RE: PZ# 24-12000026 KAJA Truck & Fleet Wash ([484234500010](#); [484234500020](#))

The above-referenced Site Plan application has been reviewed by the Development Review Committee and discussed at the April 2nd, 2025 DRC Meeting. Comments are being addressed and resolved with each discipline reviewer, though one outstanding comment is related to a necessary zoning code modification/waiver that would otherwise result in a development conflict with the City's CPTED guidelines as well as adjacent property conditions. We would like to take the opportunity to justify the need for Director modification/waiver in accordance with code sections 155.5203.F.2.e [Perimeter Buffers; Applicability].

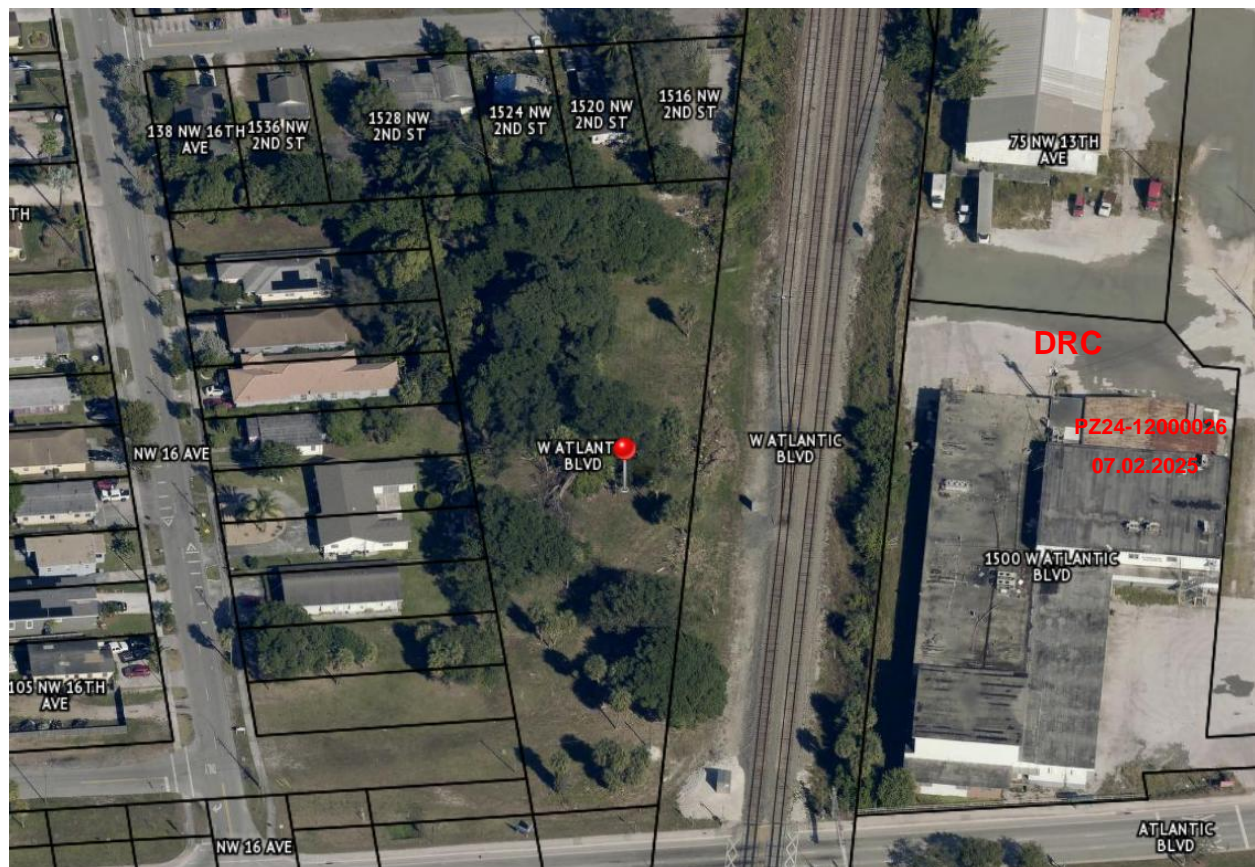
URBAN FORESTRY comment 10 states, "Provide, note and clarify the required Type B Buffer on the east side, C Perimeter Buffers on the South, West and North sides as per 155.5203.F.3. and provide a cross section detail per side."

As shown below, the property abuts residential use to the west and north where a Type C buffer is required per Table 155.5203.F.3. The car wash use is required to provide a Type B Buffer along all perimeters, unless a Type C Buffer is required as mentioned, in accordance with code sections 155.4219.A.1.b and 155.4219.H.3.e. For the safety and privacy of the residential properties, we request all buffer landscaping to be installed inside of the wall, rather than placing the wall in the middle of the 10 foot-buffer. If a wall is placed in the middle of the buffer, maintenance of the landscaping and wall will be necessary, thereby possibly facilitating a maintenance worker to trespass onto residential private property. If the residential properties include a fence or wall on their private property, an additional wall will create an "alley" of unmaintained area that invites trespassing and possibly illegal activities. Providing the fence in the middle of the east buffer would put a maintenance worker near the railroad tracks which creates an unsafe condition for the maintenance worker.

As previously discussed with BSO Deputy Anthony Russo, the east buffer should have some visibility into the site for law enforcement monitoring, which is why we propose an open picket-style fence rather than a solid fence along the east. The south buffer will include 2 barriers-- a solid wall in one portion to screen the service bay entrance, and the open picket-style fence on the other portion to provide law enforcement visibility. This buffer wall will be set back more than 30 feet from the property line.

Buffer	Barrier Material	Barrier Location
East Type B	Open aluminum picket fence, rather than solid fence	Exterior boundary of buffer, rather than middle
South Type B	Mix of solid concrete wall & open aluminum picket, rather than fully solid barrier	Middle, no modification requested
North Type C	Solid, no modification requested	Exterior boundary of buffer, rather than middle
West Type C	Solid, no modification requested	Exterior boundary of buffer, rather than middle
